From: Pederson Ronda M (AREVA NP INC) [Ronda.Pederson@areva.com]
Sent: Friday, July 31, 2009 4:15 PM
To: Tesfaye, Getachew
Cc: BENNETT Kathy A (OFR) (AREVA NP INC); DELANO Karen V (AREVA NP INC); VAN NOY Mark (EXT)
Subject: Response to U.S. EPR Design Certification Application RAI No. 155, FSAR Ch 3, Supplement 5
Attachments: RAI 155 Supplement 5 Response US EPR DC.pdf

Subject: Response to U.S. EPR Design Certification Application RAI No. 155, FSAR Ch 3, Supplement 4

QUESTIONS for Structural Engineering Branch 2 (ESBWR/ABWR Projects) (SEB2)

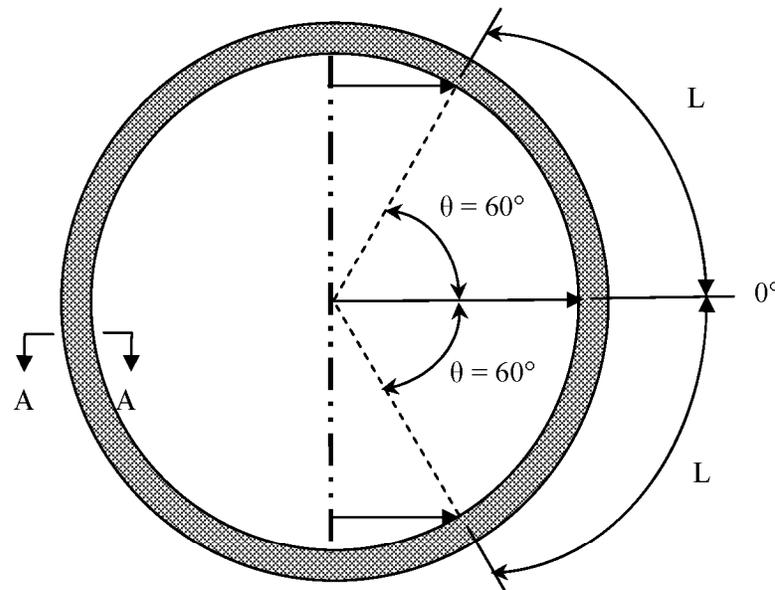
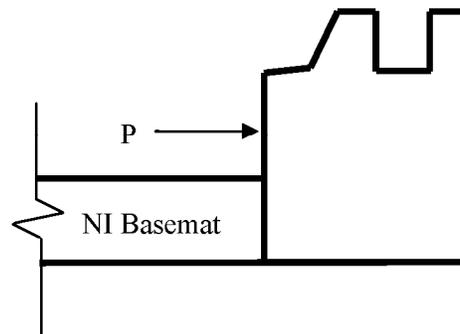
9. It is stated in FSAR Section 3.8.5.5.1, that because friction will not prevent sliding of the RB internal structures basemat above the containment liner, the surrounding concrete haunch wall is designed with sufficient capacity to resist the total base shear force. Explain how the base shear force is calculated and how the concrete haunch is designed to resist this load. Also, as discussed in item 8 above, provide a quantitative basis for the factor of safety against sliding after taking the effect of the haunch into account.

These two load combinations are then expanded to account for directionality of the various independent loadings (i.e., 100-40-40 combinations of E' and reversible value of R_a). The Response to RAI 155 Supplement 1, Question 03.08.01-2 further addresses permutations of load combination B-05 and H-05. When loads are applied to the model, ANSYS post-processing files are generated to obtain reactions at the RBIS base. These reactions include:

- R_{hx} = horizontal reaction in the x-direction
- R_{hy} = horizontal reaction in the y-direction
